**Submission with regard to Development Application DA2023/1289
Demolition works and construction of Shop Top Housing
1112-1116 Barrenjoey Road, Palm Beach, NSW**

The subject DA seeks consent for 'Alterations and additions to commercial development - demolition works and construction of shop top housing' at 1112-1116 Barrenjoey Road, Palm Beach (subject site). I have reviewed submitted DA plans and reports and considered the impacts on the character of the area and, surrounding scenic environment, which includes heritage listed items, against the

Figure 3 - 8.5 m height plane breach – note the scale of adjacent development along the Barrenjoey Road and the direct correlation with where the height breach starts to occur.

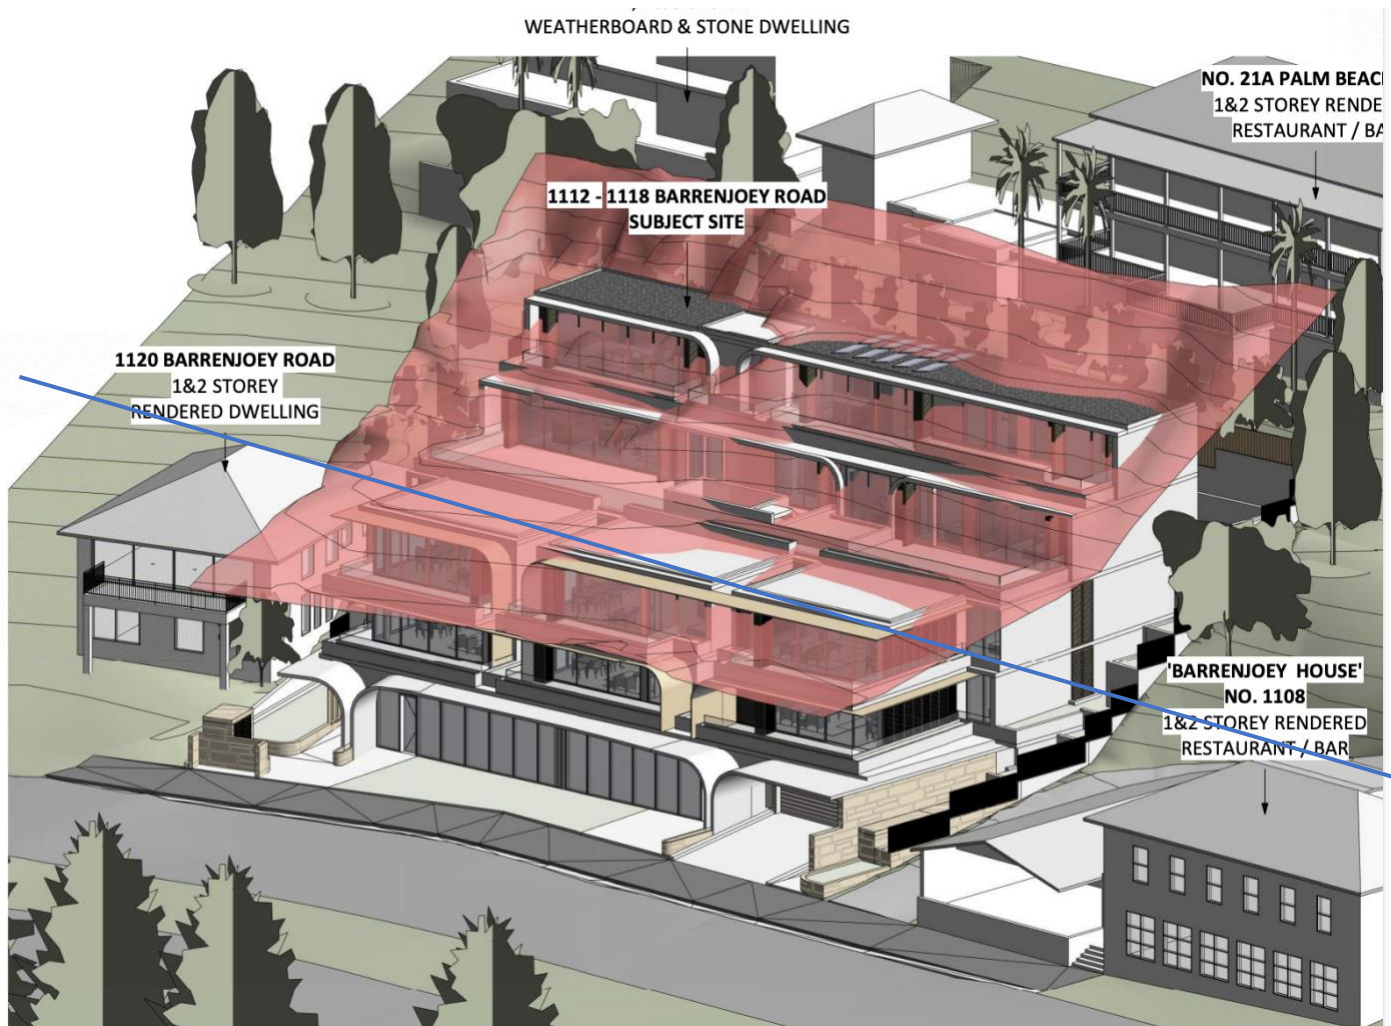
Comment: The proposed development fails to meet this objective, as already detailed in this objection and as shown in figures 3 and 4.

Clause 4.3 (2D) (a) - The height breach cannot be considered as minor. The submitted height plane diagrams demonstrate a breach of the maximum height limit at 3 of the 5 levels proposed (levels 2, 3 and 4). The top two levels have been recessed into the site and overhang the rear setback in an attempt to reduce the breach and give rise to additional impact on neighbouring amenity, visual impacts and building separation distances. A breach of the maximum height of buildings across 3 of 5 levels of a development cannot be considered as minor.

- Remove levels 3 and 4 from the proposed development and strictly comply with the 8.5 metre height limit.
 - Pull back the rear and side elevations of the proposed development to strictly comply with the ADG. 6-12 metre building separation distances are required.
